**STAFF RECOMMENDATION**

**922 Russell Street**

**April 17, 2019**

**Application:** New Construction—Infill and Outbuildings

② Contextual Elevations With New Structures- Facing South

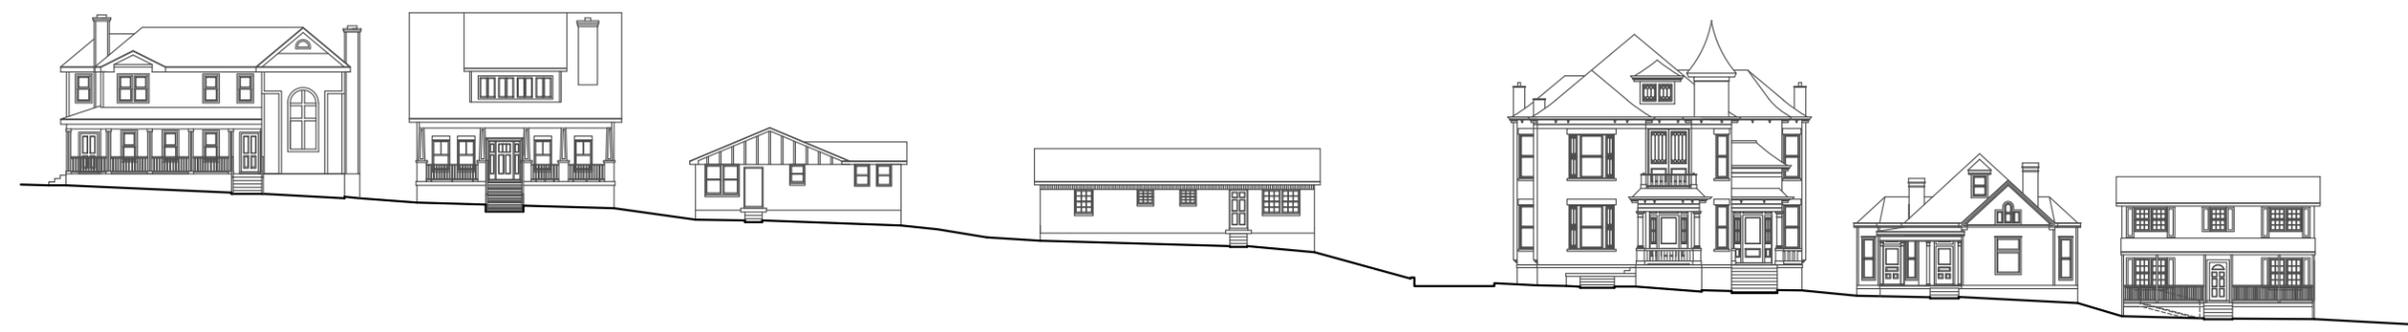
Height & Scale: The two houses will both be two stories. "House A" will have a ridge height of approximately twenty-nine feet, ten inches (29'-10") whereas "House B" has a maximum ridge height of thirty-five feet (35'), both measured from grade. The immediate context is a mix of one, one-and-one-half story, two, and two-and-one-half story historic houses with heights ranging from twenty-one feet to thirty-nine feet (21'-39'). While the proposed infill heights seem to be on the taller end, staff finds that when the context of the block face is considered with grade, the proposed two-story houses could be appropriate. The applicant provided a scaled streetscape plan that illustrates how the proposed infill will relate to the context (Figure 2).
